# UNITED STATES FUEL COMPANY

RE: Request for approval on  
sediment pond inspection  
schedule.

RE: North Fork Vent Portal Discharge  
Diversion Modification  
Hiawatha Complex  
ACT/007/011, Folder No. 3  
Carbon County, Utah

FIGURE 5

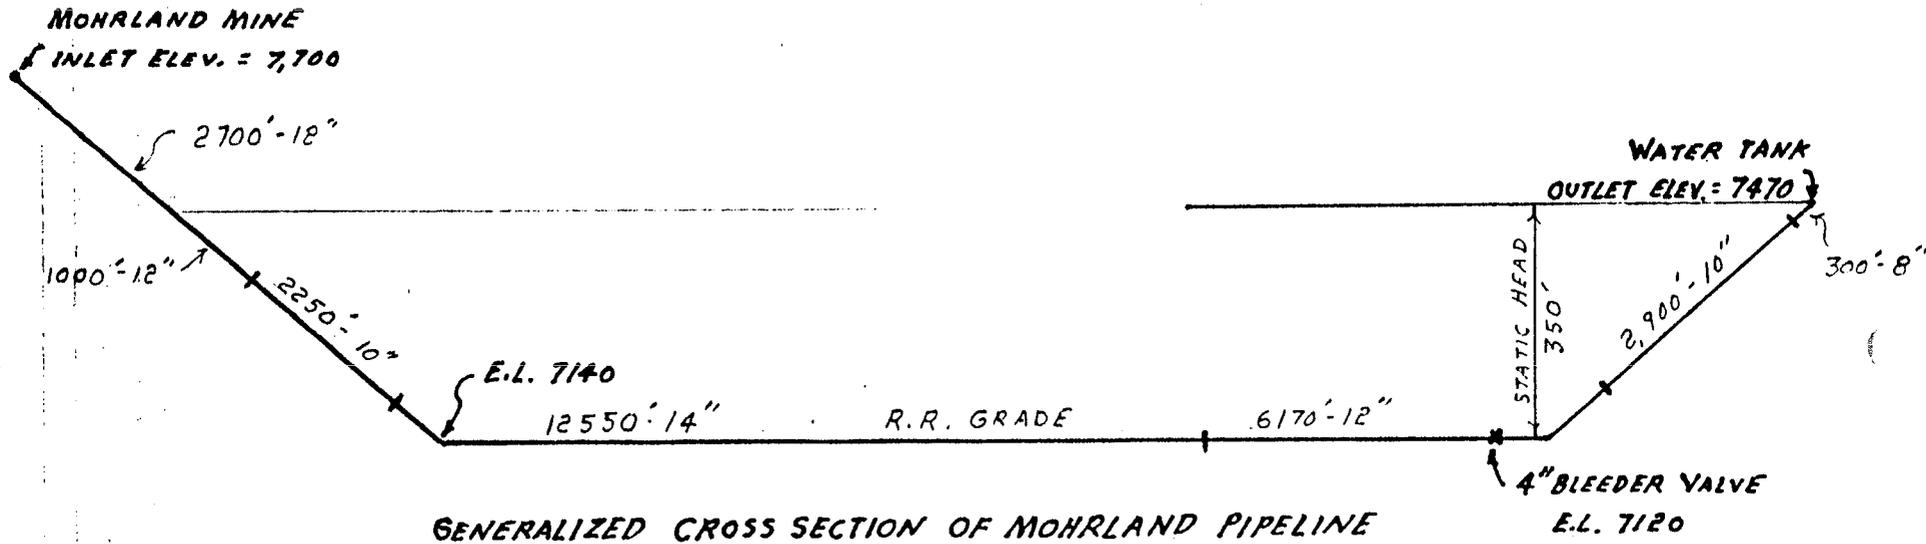
1. Calculations showing the velocity and discharge rates of outflow from the 4 inch water line.
2. Ten year 24 hour discharge rate entering the 36 inch culvert from the contributing drainage area supported by calculations, drainage areas methodology and any assumptions used .
3. Literature citations and/or any other documentation supporting use of railroad ties as energy dissipators.
4. Clarification of where the proposed fill material will come from and an explanation of how this will not cause any additional disturbance.
5. A copy of a letter to EPA and State Health informing them of the emergency discharge point and requesting guidance from them in regards to any permitting of the discharge point which may be necessary (i.e. NPDES).

- 1) Calculations showing the velocity and discharge rates of outflow from the four inch water line. Assumptions and calculations are given in Figure 5. Figures 6, 7 and 8 give charts showing the relationships of velocity vs head, discharge rates vs head and head vs time. These charts are derived from equations given in Figure 5.

# Slurry Pond #5b Modification

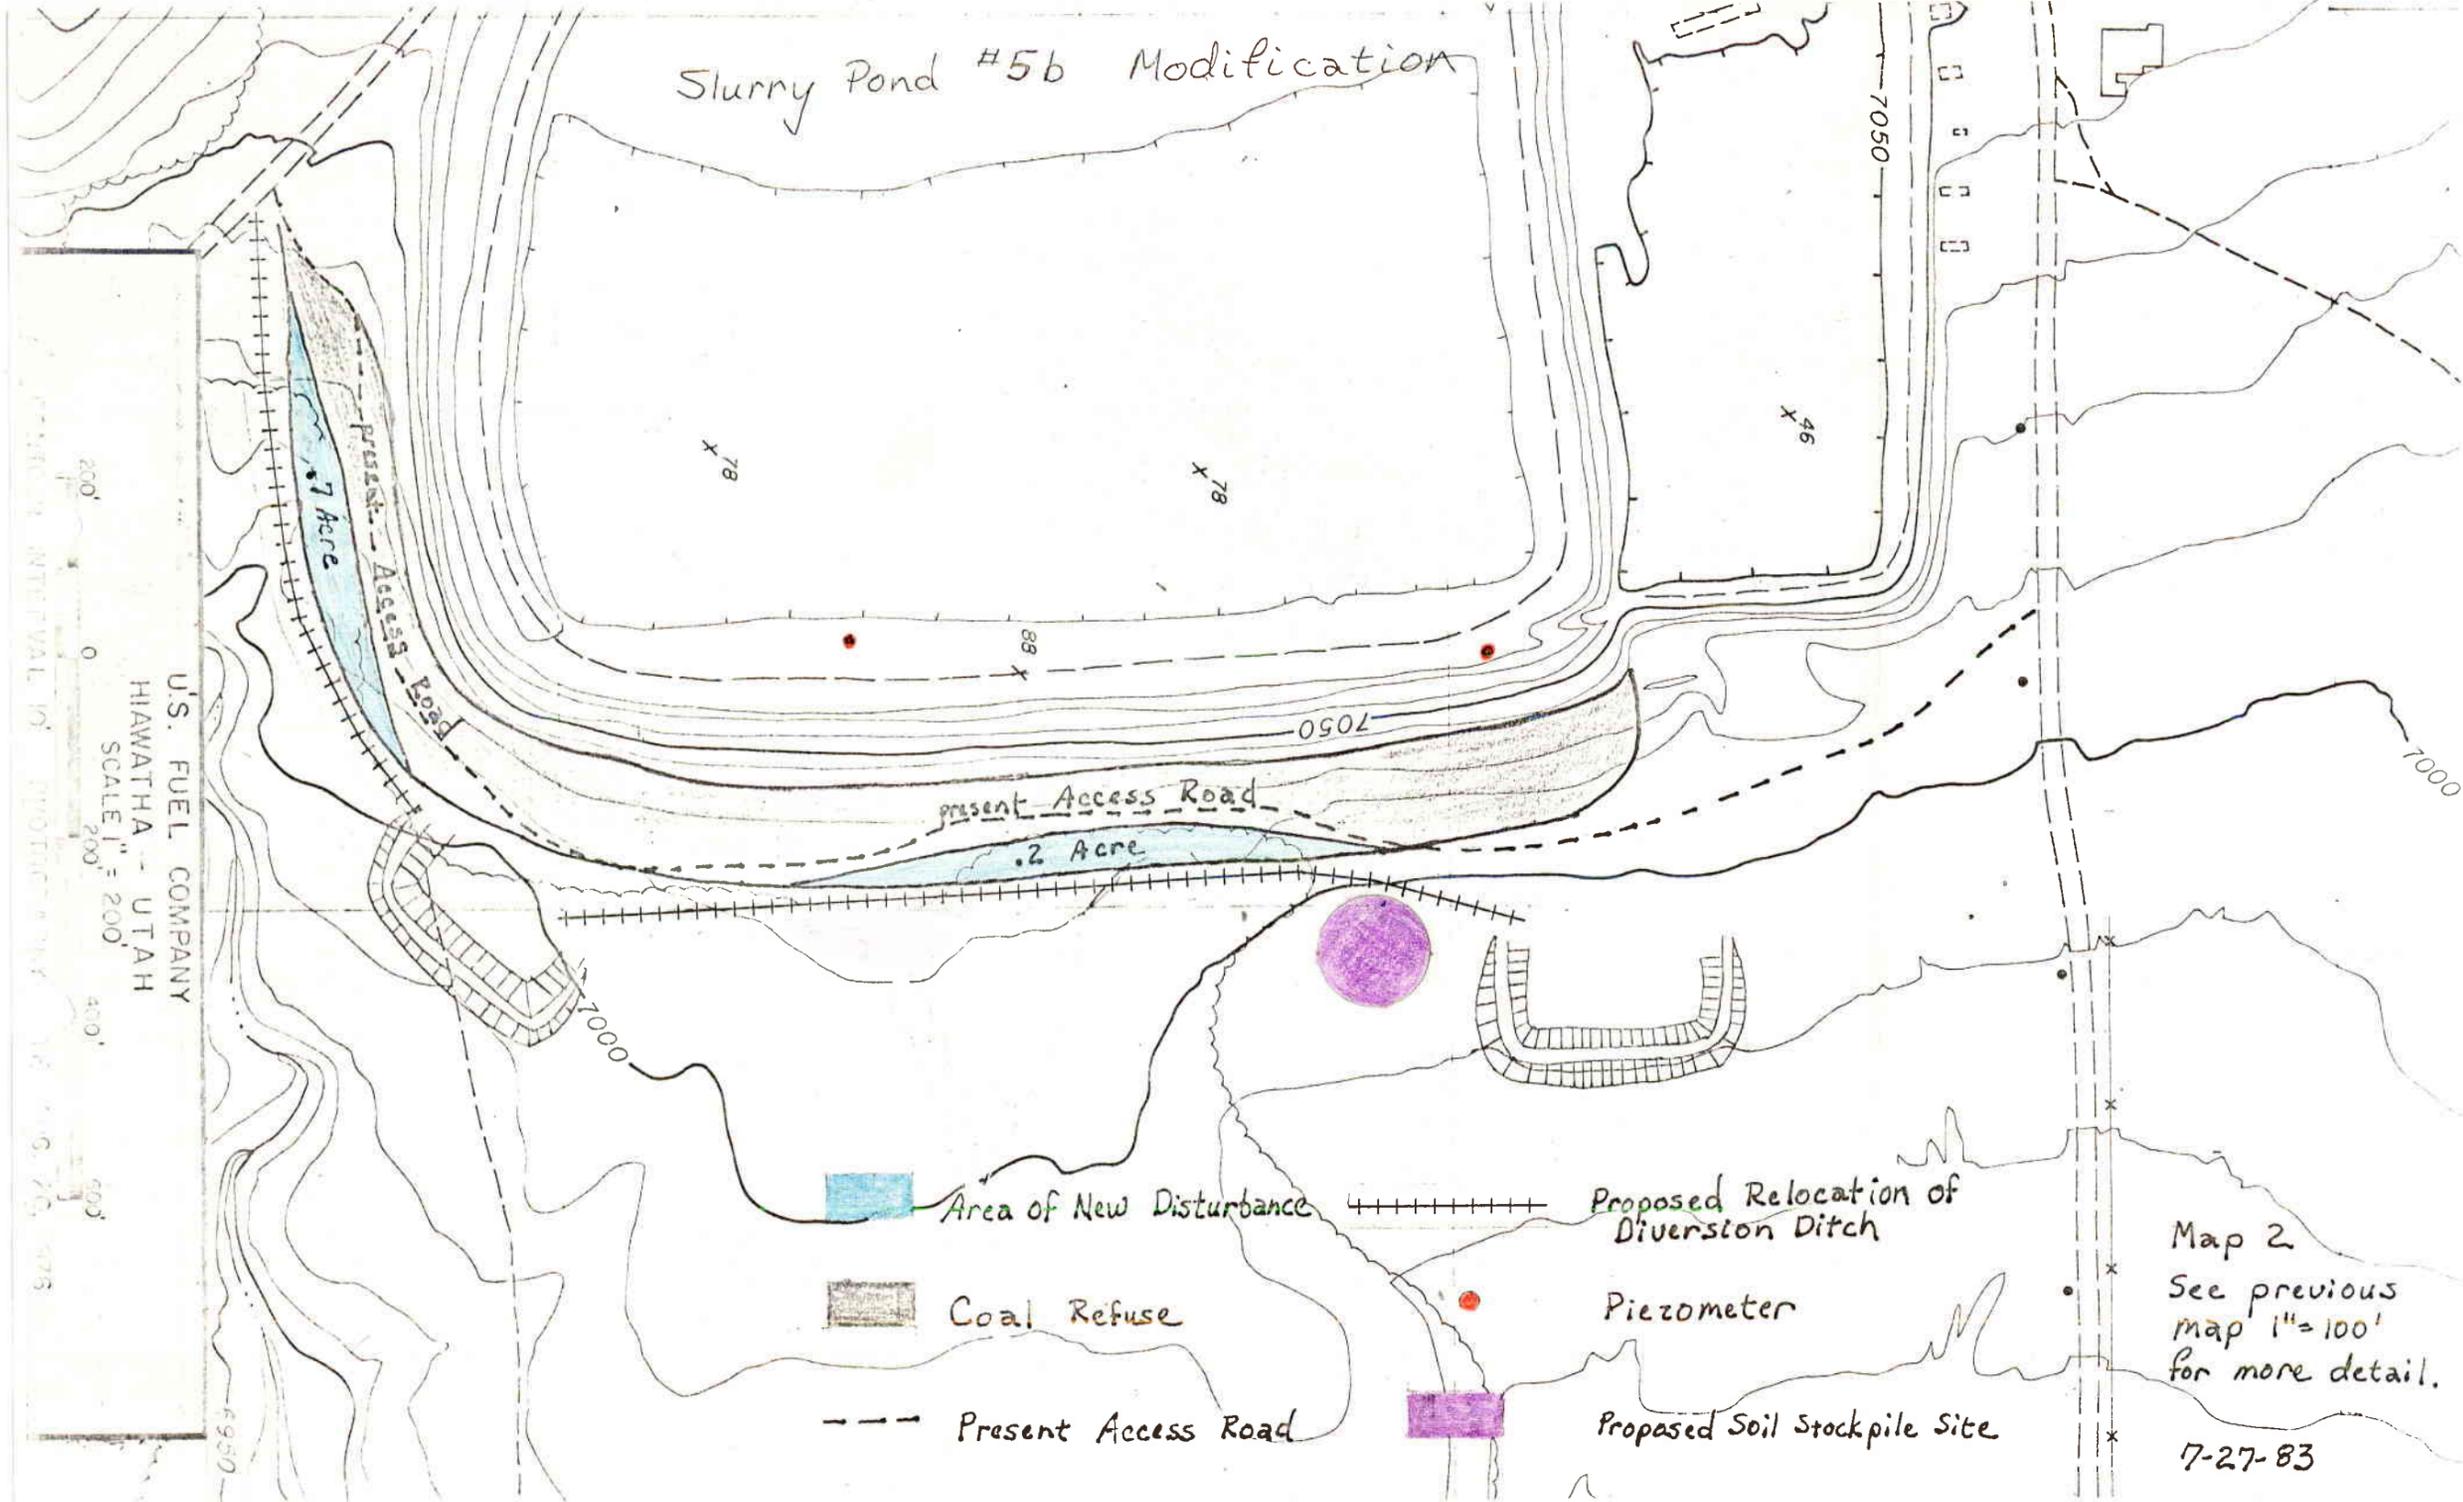
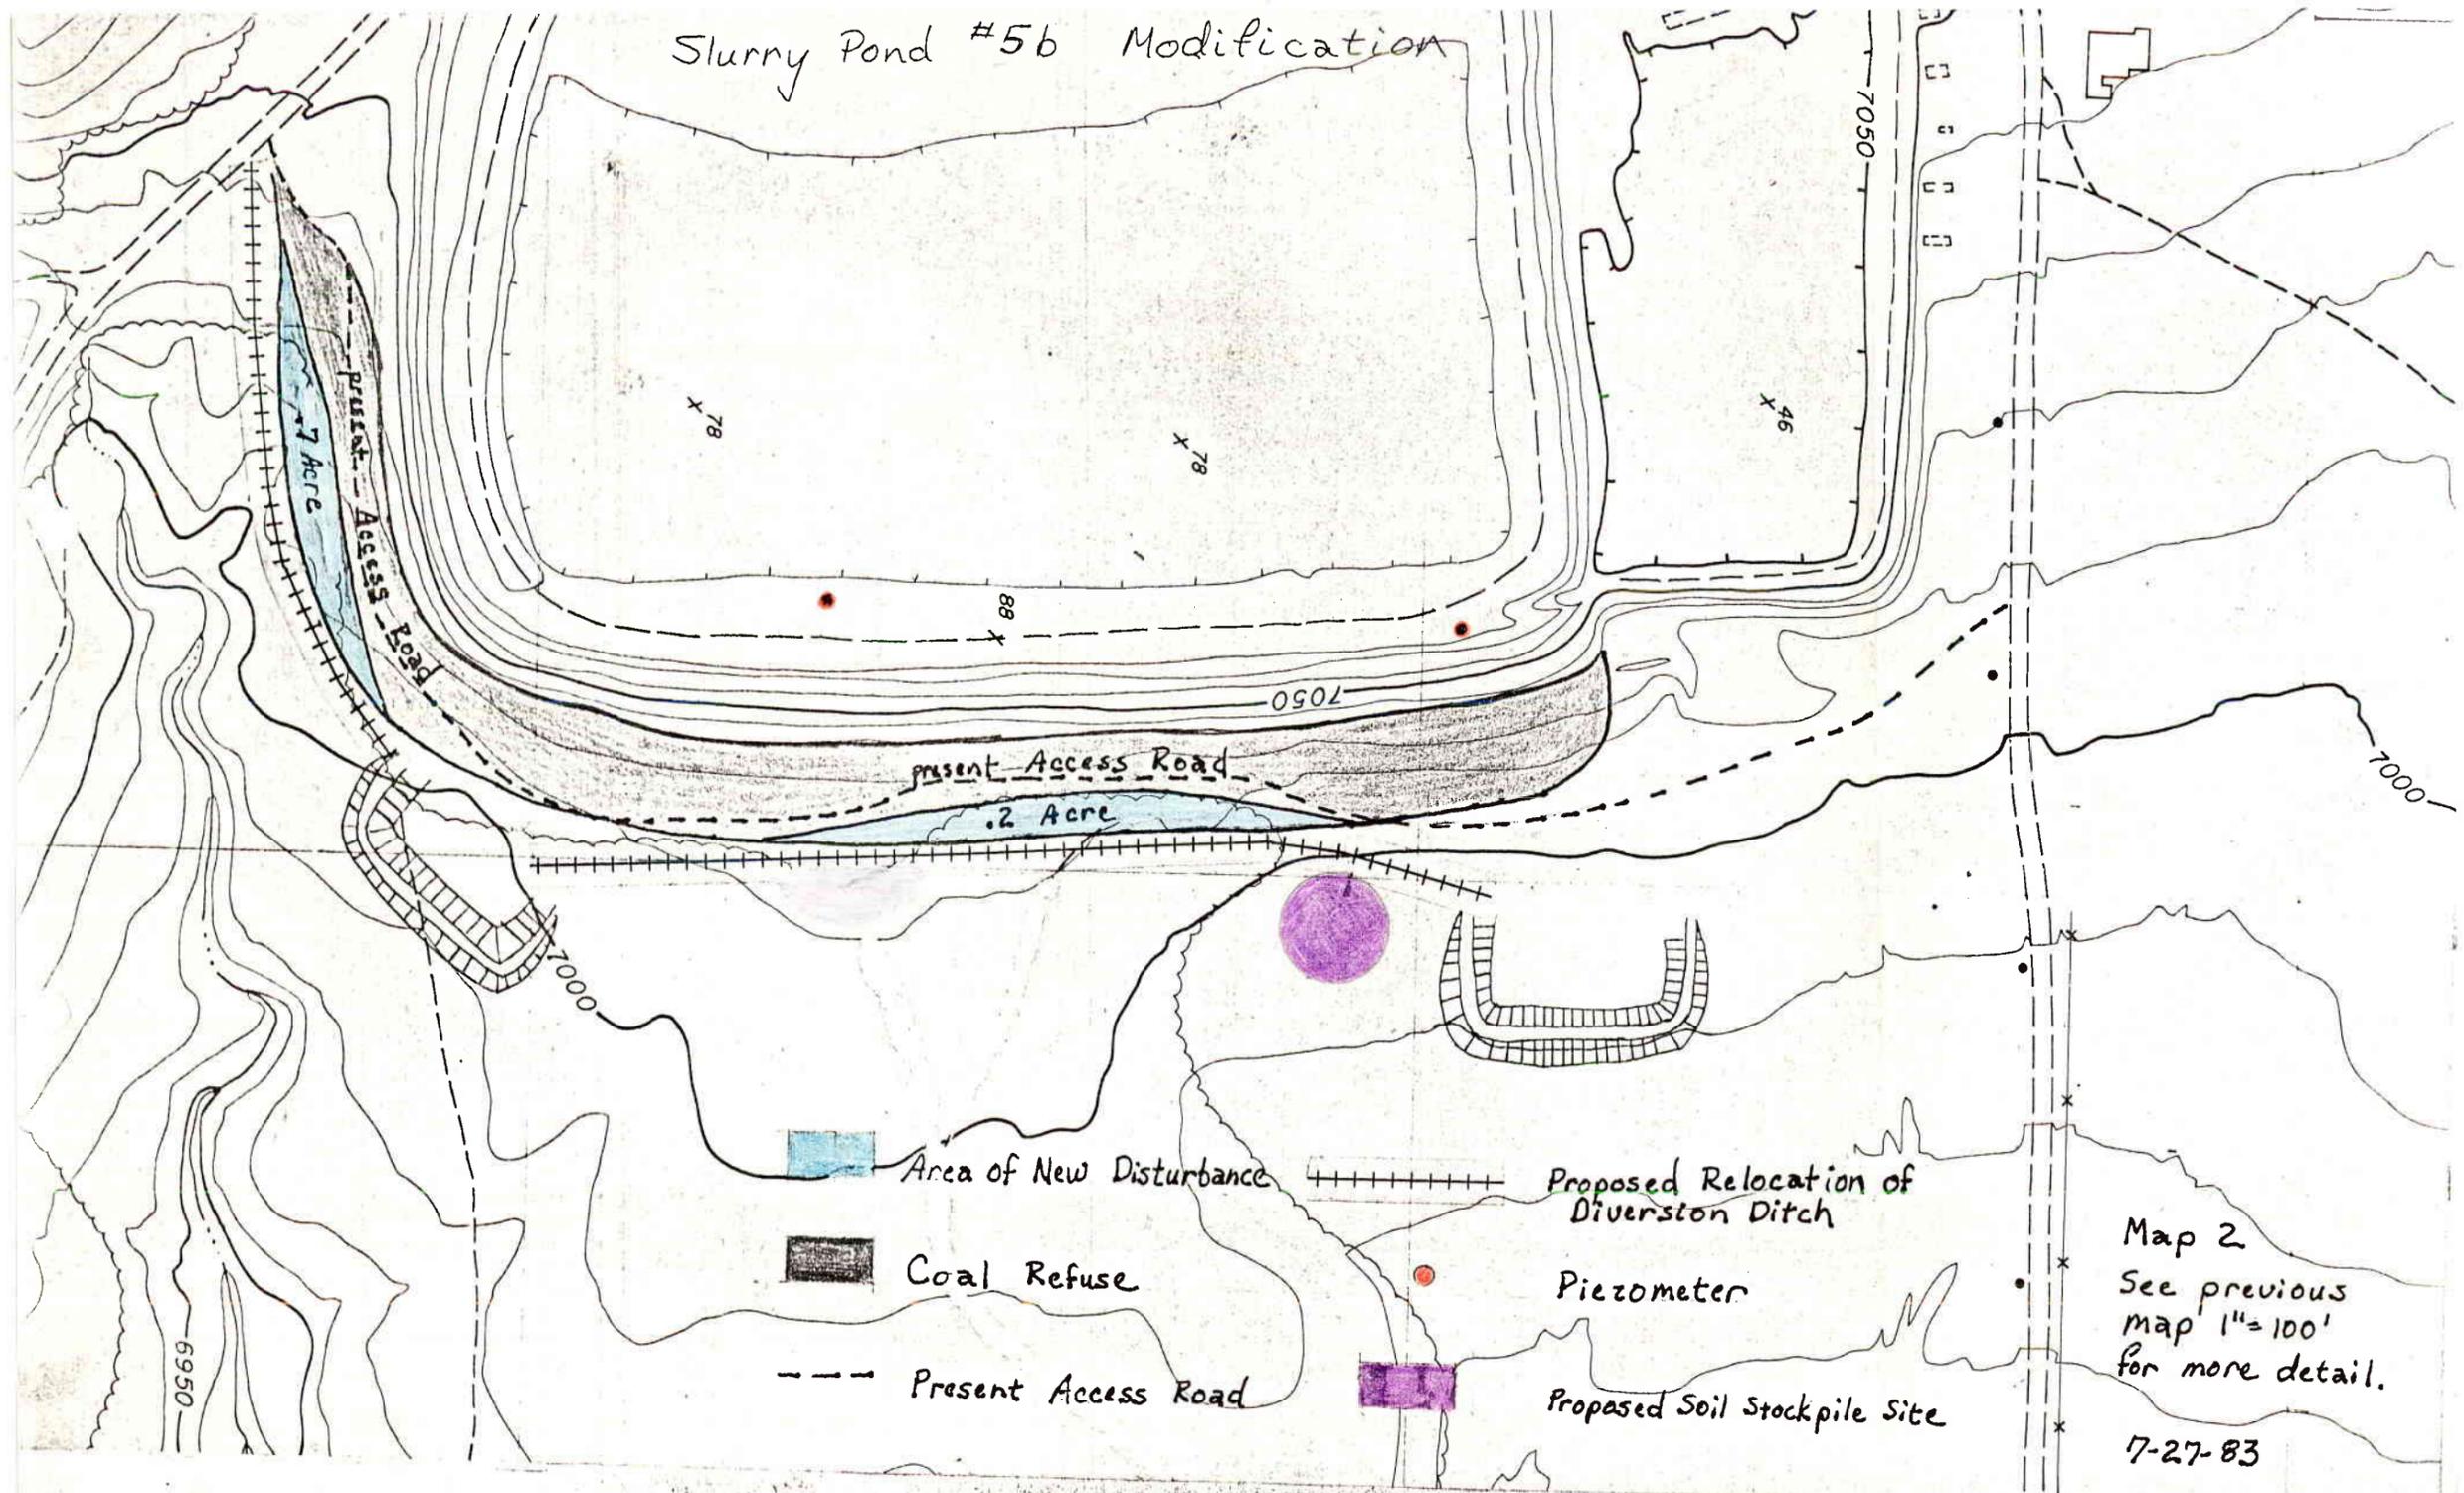
1. Since the operator indicates that subsoil material below the one foot level is excessively rocky (70 percent), how will forthcoming soils data be interpreted? What would be the rationale for change in the expected volume of topsoil storage (page 4)?
2. On page 2 of the August 1, 1983 submission an estimate of 39,204 ft<sup>3</sup> is provided for the expected volume of salvagable topsoil. The text then refers to removing large boulders from the topsoil. How might the expected salvage volume be altered accounting for the boulders?
3. The peak flows calculated by the operator for the two diversion ditches to be constructed are questionable. Upon cross-checking the operator's method, the Division calculated peak flows (Q<sub>p</sub>) of 11.28 cfs and 18.63 cfs for the south and north ditches, respectively.

During the Division's field observation of the area, we had discussed the construction of a road at the new toe of the stability berm to serve as a diversion ditch. This will keep the required new disturbance to a minimum. Refer to the enclosed calculations which size the diversion ditch. This ditch will surround the entire new disturbance on the down slope side and will collect and convey runoff from the disturbed area into the sediment ponds. Volume calculations show the ponds to have sufficient capacity to handle the additional .9 of an acre disturbance. Refer to the enclosed calculation sheet. The location of the new diversion ditch is shown on the enclosed map.
